Subject: Contract No. DE-AC06-93RL12367
**ELIMINATION OF ADMINISTRATIVE TECHNICAL SAFETY
REQUIREMENTS ON EF-8 FAN AND HIGH EFFICIENCY PARTICULATE
AIR FILTERS IN THE REDUCTION OXIDATION BUILDING**

UNREVIEWED SAFETY QUESTION SAFETY EVALUATION FORM
PU LOADOUT HOOD STABILIZATION
DIS #: 0200W-US-N0156-02, Rev. 2*

Purpose: Revision 2 of this USQ Safety Evaluation evaluates the revised scope of work to stabilize the Pu Loadout Hood (a.k.a., Product Receiver Cage, PR Cage and Plutonium Loadout Hood). Revisions 0 and 1 evaluated the preliminary scope of work, the resultant configuration and additional sample data taken in the North Sample Gallery and Pu Loadout Hood. Evaluation of the seismic event, which was included in Revisions 0 and 1, is addressed separately in USQ, 0200W-US-N0175-02. Applicable changes to the SAR are included in this USQ and will be issued in a subsequent annual update.

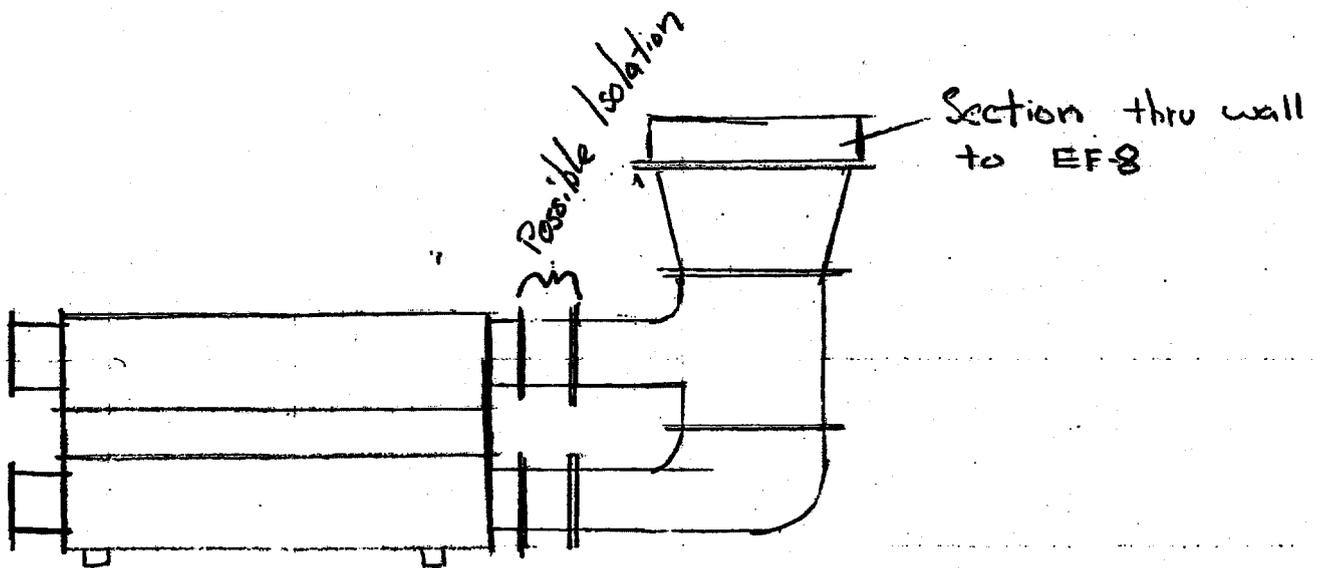
- On the front face of the hood there are three connections to the supply ventilation ductwork. Bolted transition pieces provide for a relatively easy installation of isolation blanks to isolate potential infiltration sources into the hood.

- The east end of the PR Cage may be adequately isolated with a covering that is mounted to

the frame work of the cage and to the floor. The bottom connection needs to consider a seal at the floor line because there is no curbing as there is around the remainder of the hood. The covering need only be a high as the lower frame work which is approximately 3 foot from the floor surface and is just below the air gage. The upper section of the east end appears to be equivalent to the remainder of the PR Cage.
